From: Ann Horowitz
Sent: Friday, June 02, 2017 4:29 PM
To: Kim Dobbin; Kristen Walentisch
Subject: FW: 170530- 105/107 Uhler.docx
Attachments: 170530-Uhler.docx

SCF2017-0028
Additional Materials
6/6/17

DATE: June 6, 2017
FROM: Anna Jaeger
TO: Jordan Taylor, Ann Taylor, Tony Culley-Foster & Nicole Basso

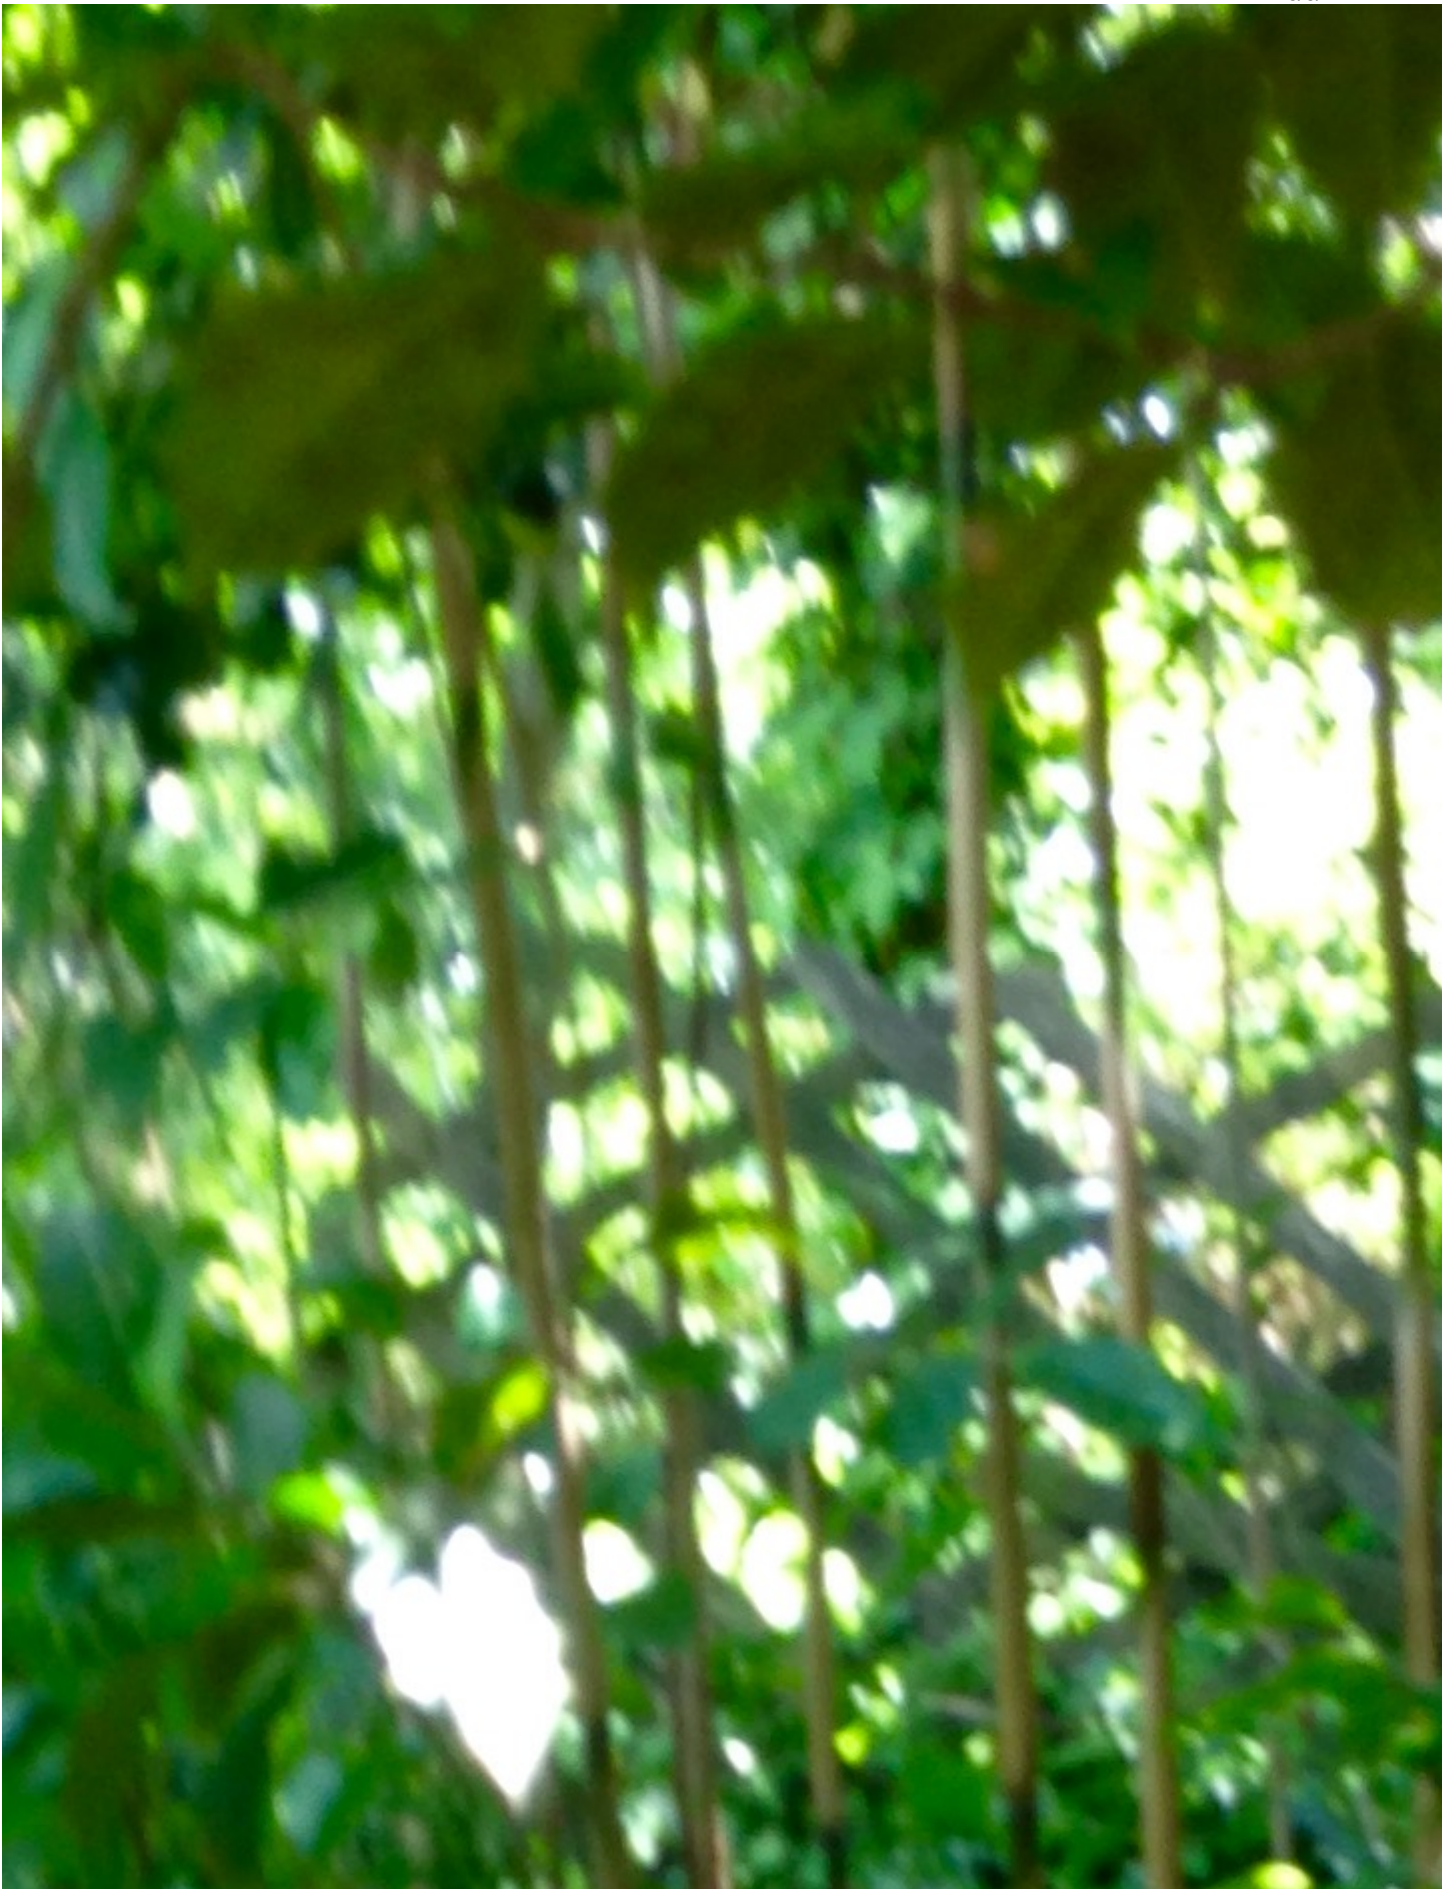
Ann,
Bamboo behind my studio are
growing back as usually.
Thank you
Nicole & Tony
